MEMORANDUM
Town of Nags Head
Planning & Development Department

To: Planning Board
From: Kelly Wyatt, Planning Director
Joe Costello, Deputy Planning Director
Date: November 14, 2024
Subject: Site Plan Review, 105 W. Seachase Drive

Purpose/Request: Construction of an approximately 8,305 square foot Dare County Emergency Management Services (EMS) station and all associated site improvements. Note that "Future Additions" are not included as part of the Site Plan Review.

SITE PLAN
PRELIMINARY

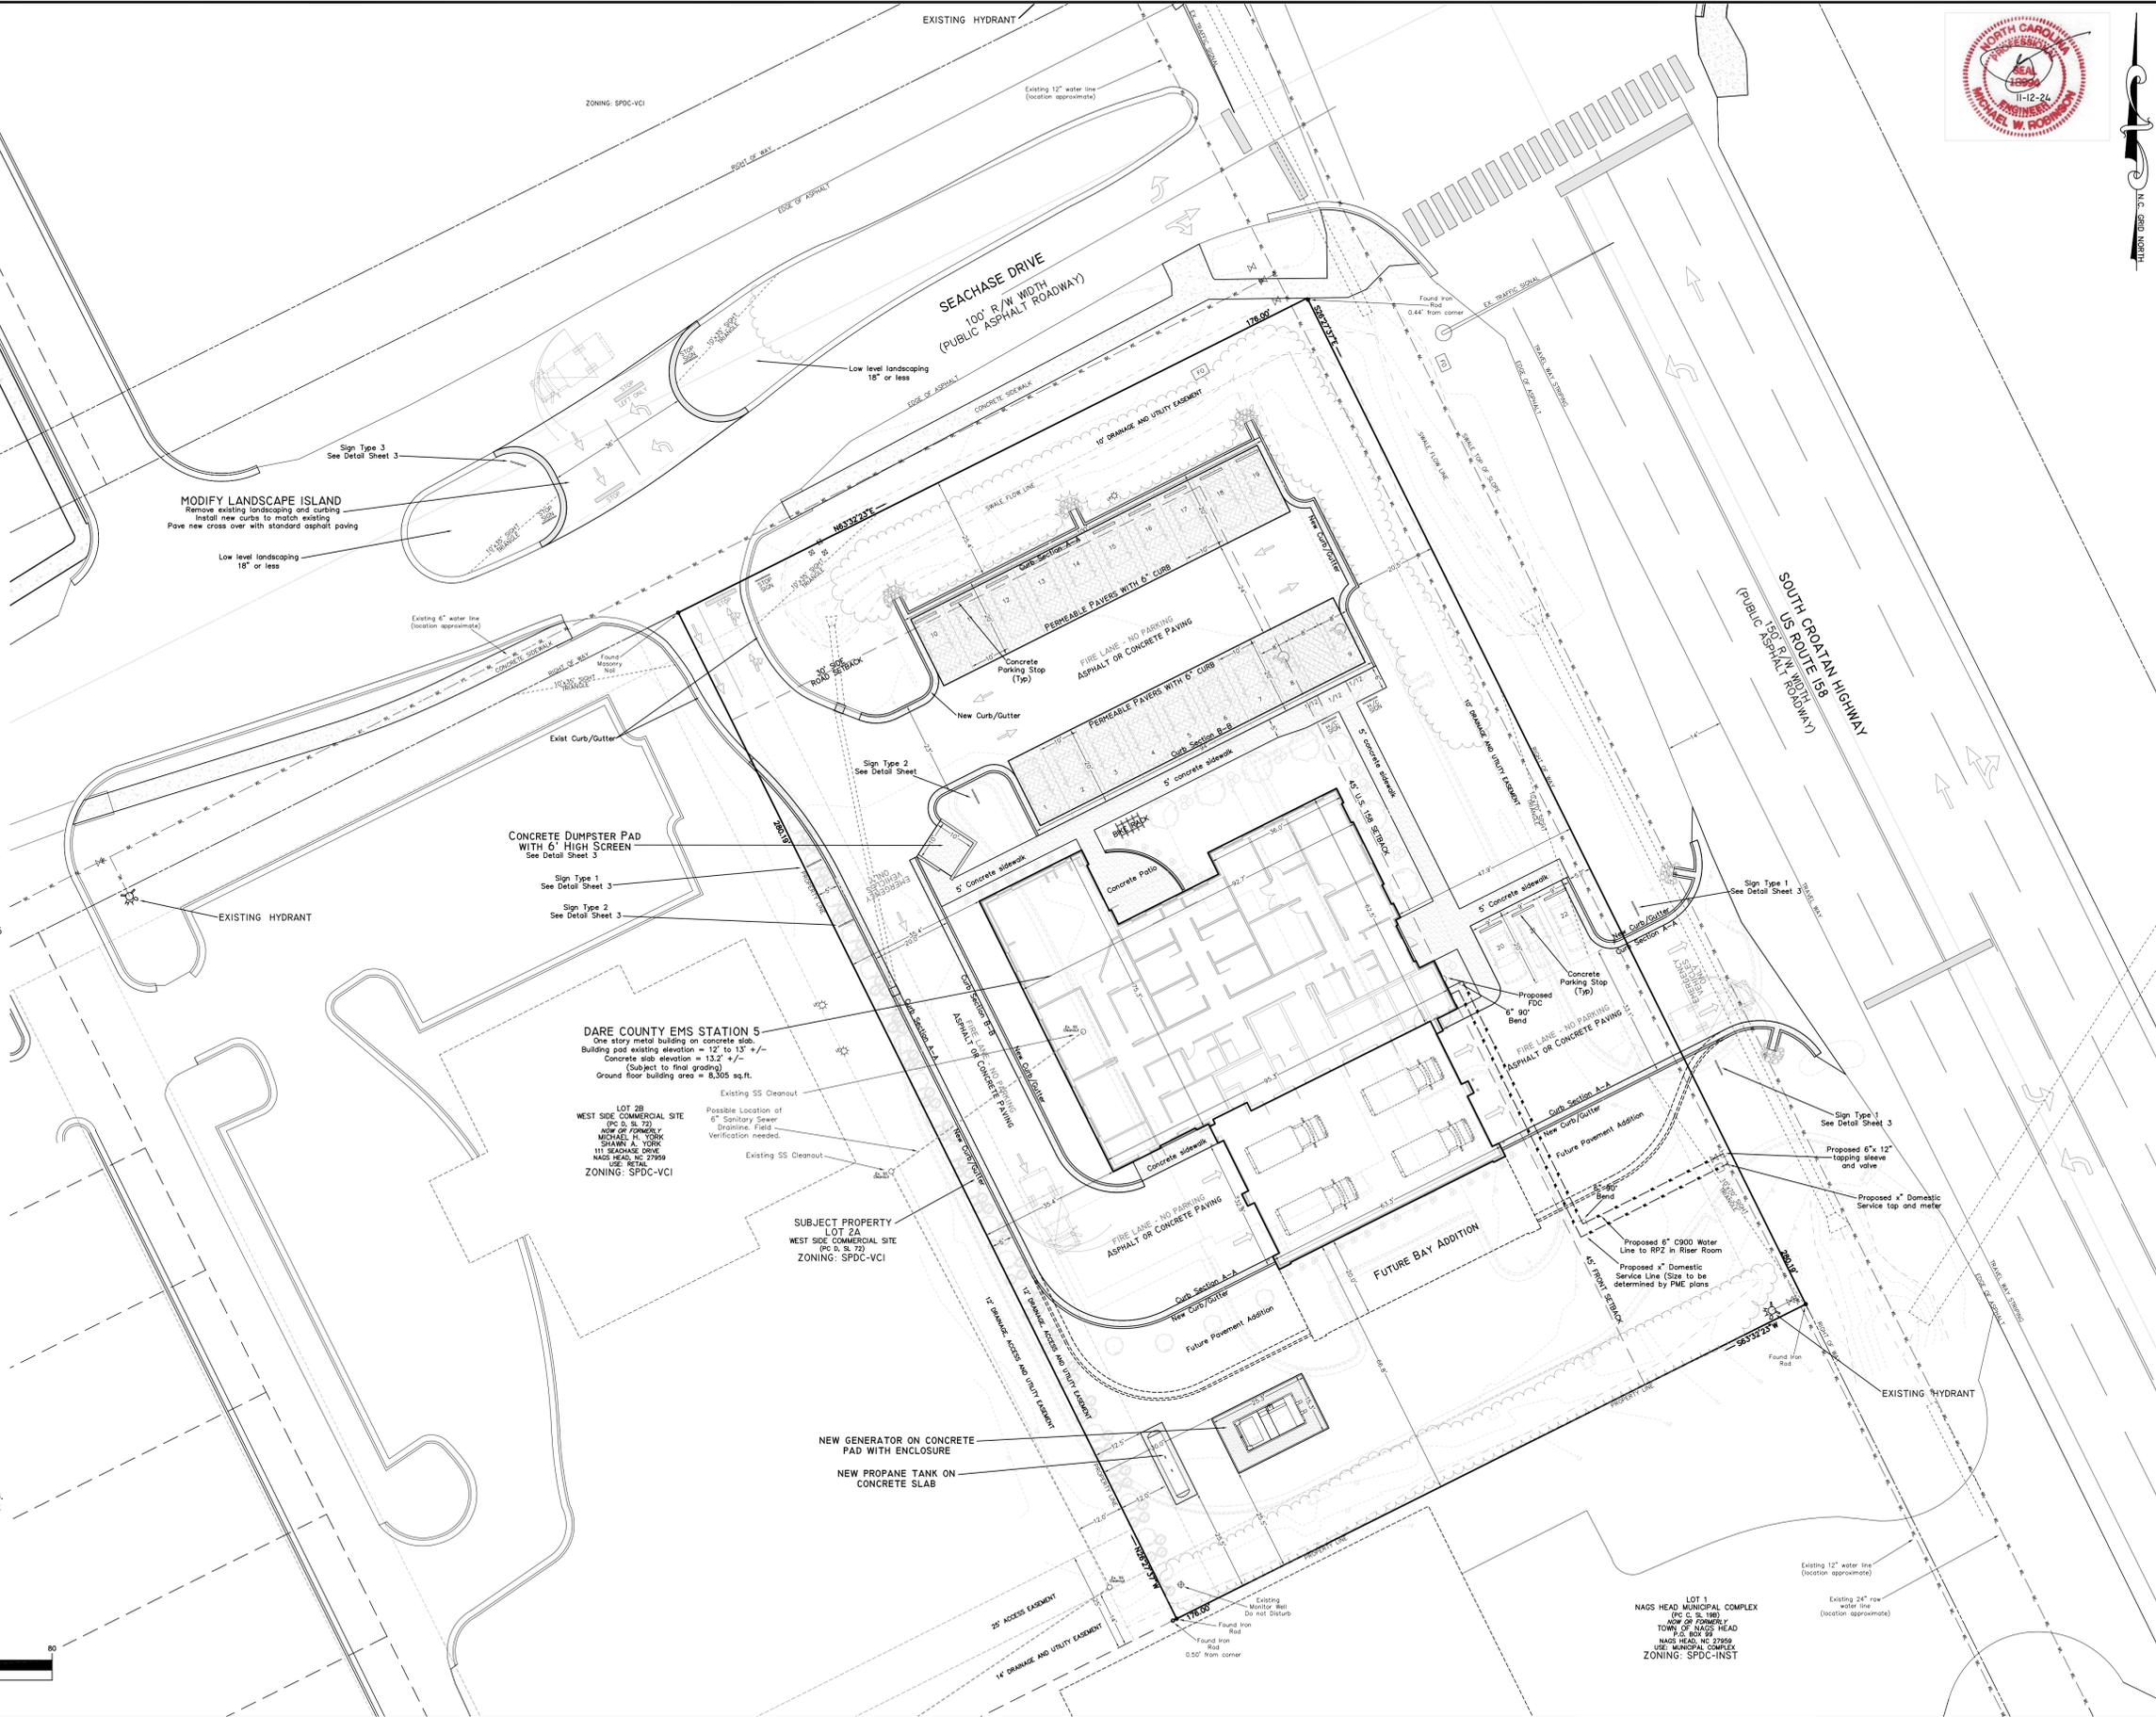
- Parking: At their November 6, 2024, meeting the Board of Commissioners adopted a parking standard for EMS Stations of one (1) parking space per employee on duty and one (1) parking space per 200 square feet of training facility and customer service areas. The applicant has noted a maximum of 12 employees at shift change, requiring 12 parking spaces, no training areas and approximately 100 square feet of customer service area, requiring one parking space. This use is required to have a minimum of 13 parking spaces, 22 spaces have been provided, therefore parking is compliant.

Section 10.92.14.4 of the UDO, Surface Materials Appropriate for use, requires that a minimum of twenty (20) percent of the surface area of the parking area and drive aisles be constructed using permeable surface materials. The applicant

has proposed 22.6% of the parking area be provided in an approved permeable surface therefore this requirement is compliant.

Section 10.92.6.2 of the UDO, Parking and Drive Aisle Setbacks, requires that where off-street parking is provided between the building and the street right-of-way line, a parking lot buffer of at least ten (10) feet in width shall be provided between the parking lot and the street right-of-way. A compliant buffer has been proposed along the northern property boundary, adjacent to W. Seachase Drive, and along the eastern property boundary adjacent to US Hwy 158. Note that this includes preserving and maintaining existing mature vegetation in these areas.

Traffic Circulation: Traffic circulation has been reviewed and approved by the Town Engineer as presented, noting that an NCDOT right-of-way encroachment agreement will be required prior to issuance of the building permit.

SEDIMENTATION/EC PLAN
 LANDSCAPE/BUFFER PLAN
 GRADING / DRAINAGE PLAN

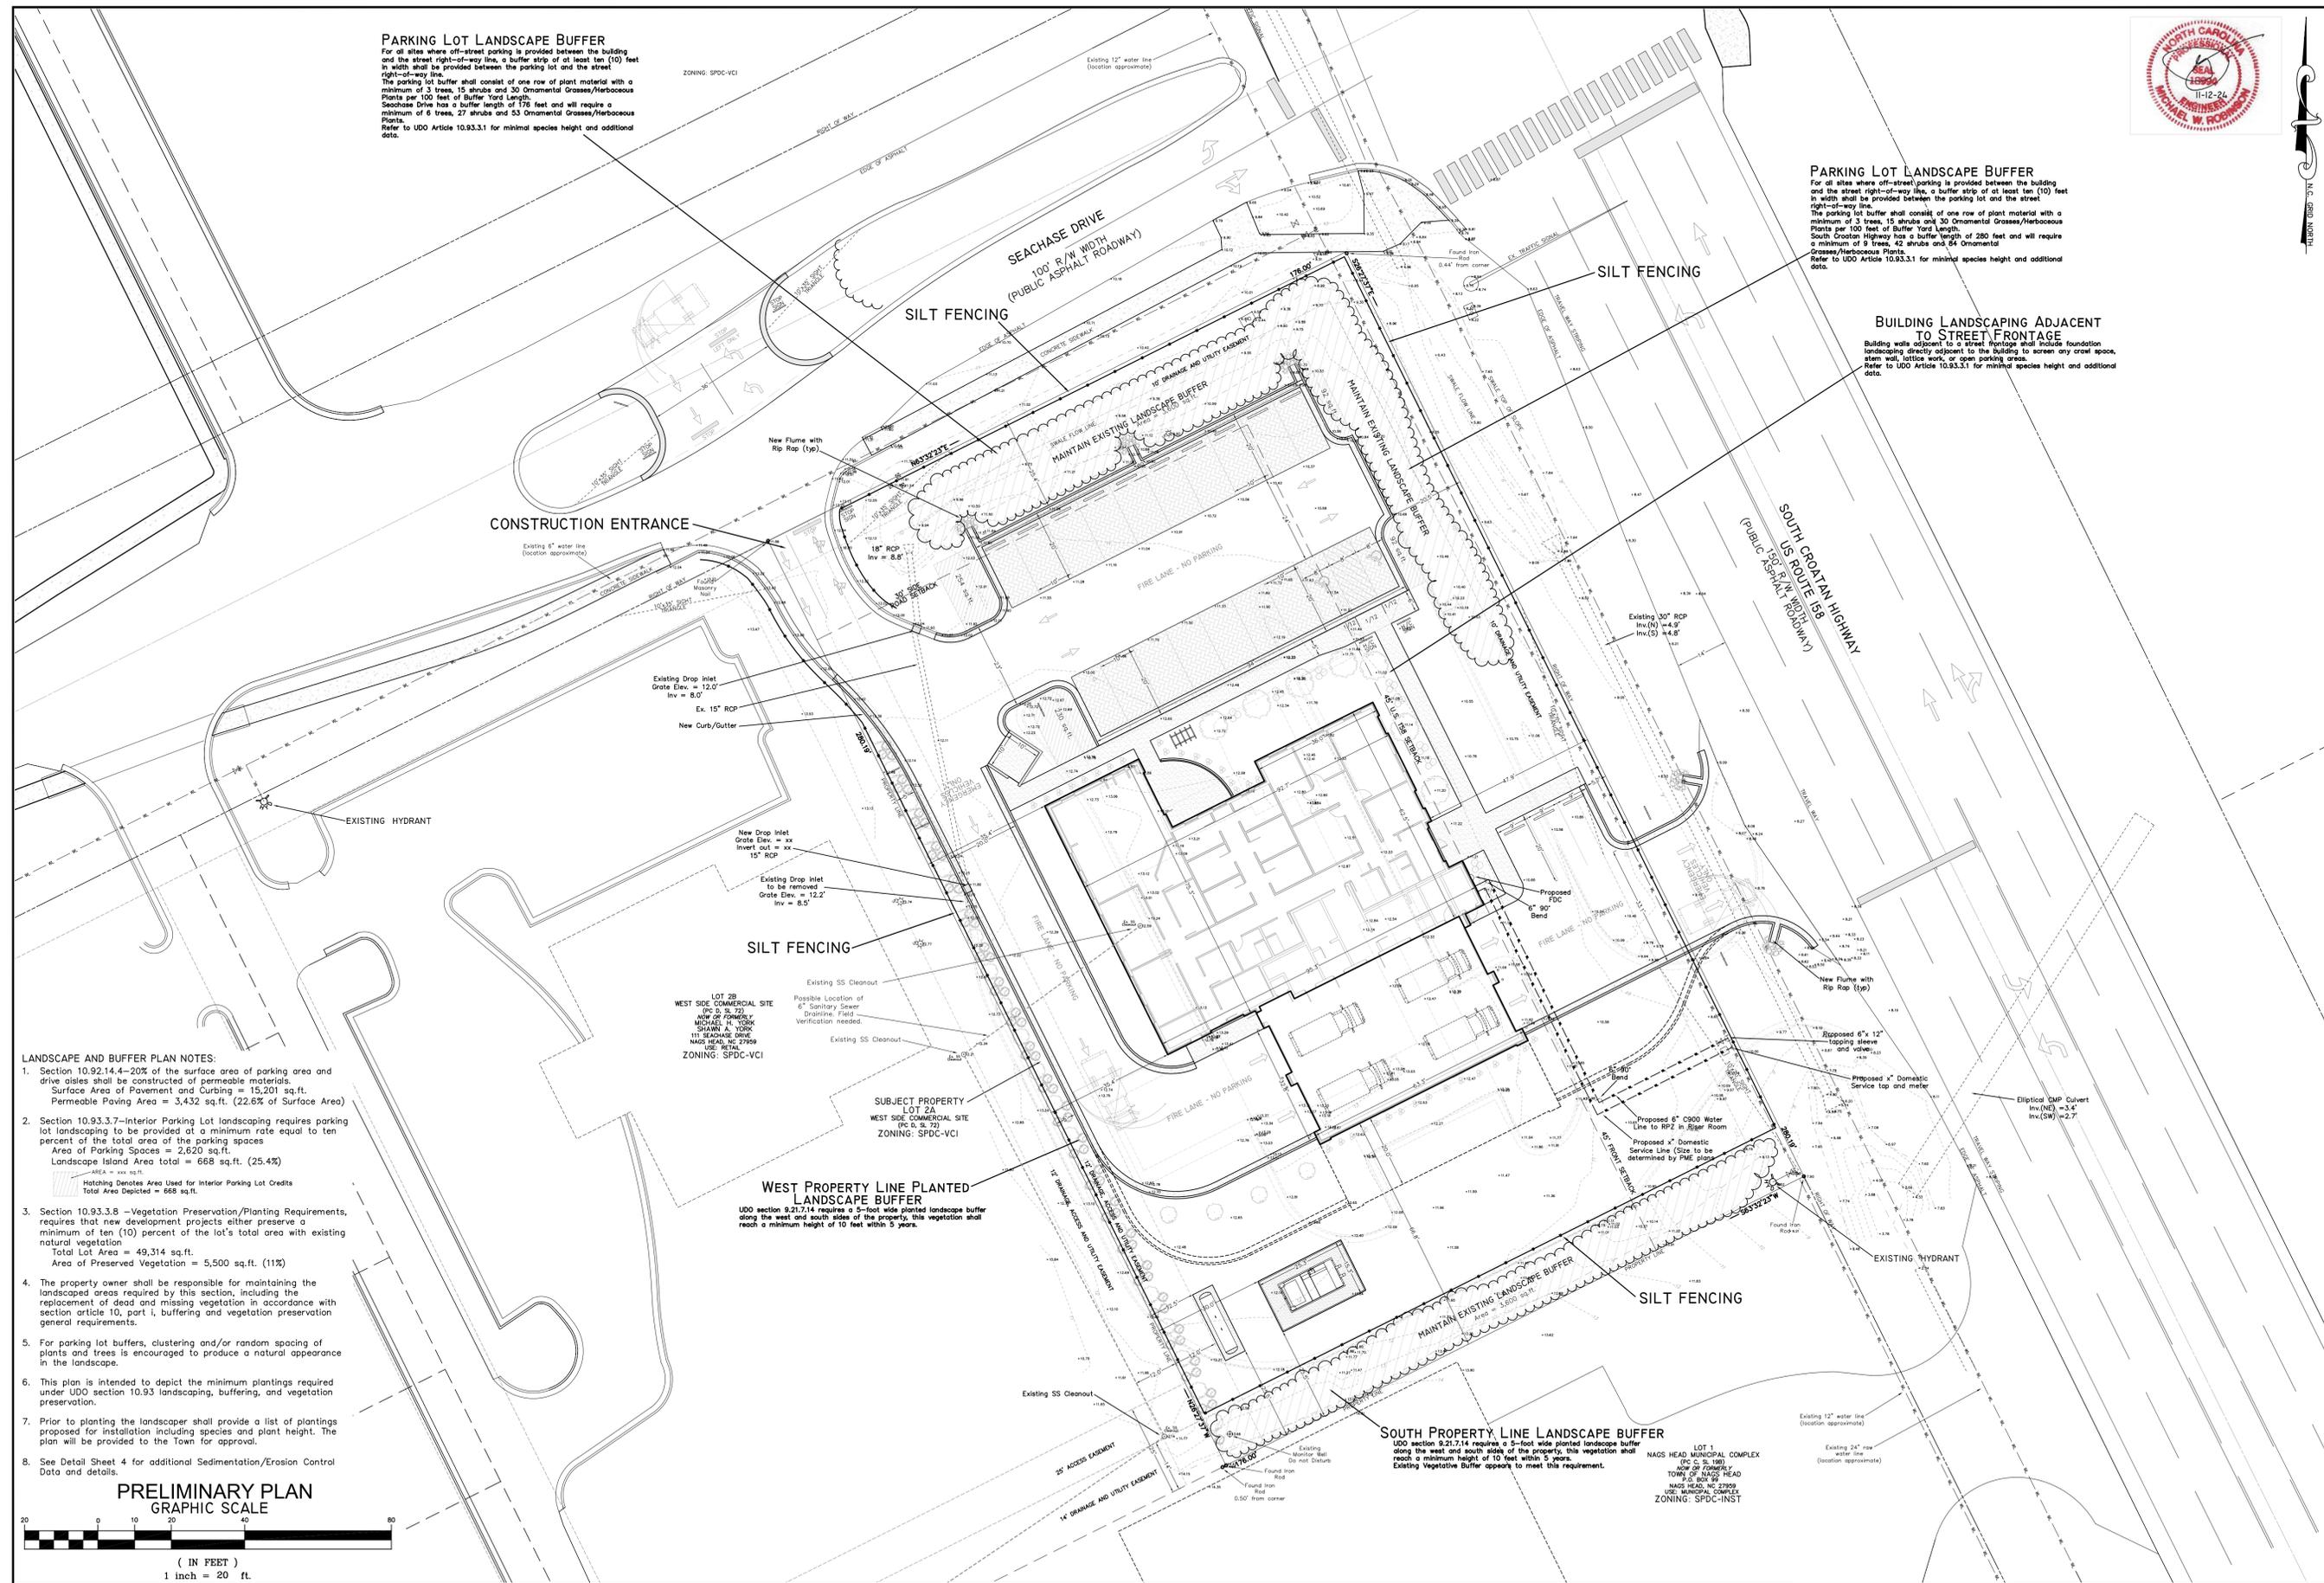
- Buffering/Landscaping: Buffering/Landscaping: Several sections of the Unified Development Ordinance speak to Buffering and Landscaping as it applies throughout this proposed site:

Section 9.21.7.14, General Provisions with the Village Commercial-1 District states that a buffer shall be maintained along property lines abutting any neighboring lots not a part of the shopping center (implying C-1 designation). The buffer shall be a 50-foot-wide grassed open space or a vegetated buffer of a minimum width of 5 feet that will reach a minimum height of 10 feet within five years. Sheet 2 of 5 of the Site Plan review packet demonstrates compliance with this provision, including preserving and maintaining a significant stand of mature vegetation along the southern property boundary.

Section 10.93.3.5 of the UDO, Buildings Adjacent to Street Frontage, states that building walls adjacent to a street frontage shall include foundation landscaping directly adjacent to the building to screen any crawl space, stem wall, lattice work, or open parking areas. The applicant proposed landscaping along the building foundation adjacent to US Hwy 158 and W. Seachase Drive and is therefore compliant.

Section 10.93.3.7 of the UDO, Interior Parking Lot Landscaping, requires parking lot landscaping be provided at a minimum rate equal to ten percent of the total area of the parking spaces. The applicant has proposed 25.4% of the total area of parking spaces in compliant landscaping, therefore interior parking lot landscaping is compliant.

Section 10.93.3.8 of the UDO, Vegetation Preservation/Planting Requirements, requires that new development projects either preserve a minimum of ten (10) percent of the lot's total area with existing natural vegetation and/or dune elevations or plant new vegetation in lieu of preservation. When existing vegetation cannot be preserved, the planting of a minimum of fifteen (15) percent of the lot's total area shall be required. The applicant has proposed to preserve all the existing mature vegetation onsite, resulting in 11% of the total lot area, in addition to the proposed new plantings, therefore vegetation preservation requirements are compliant.
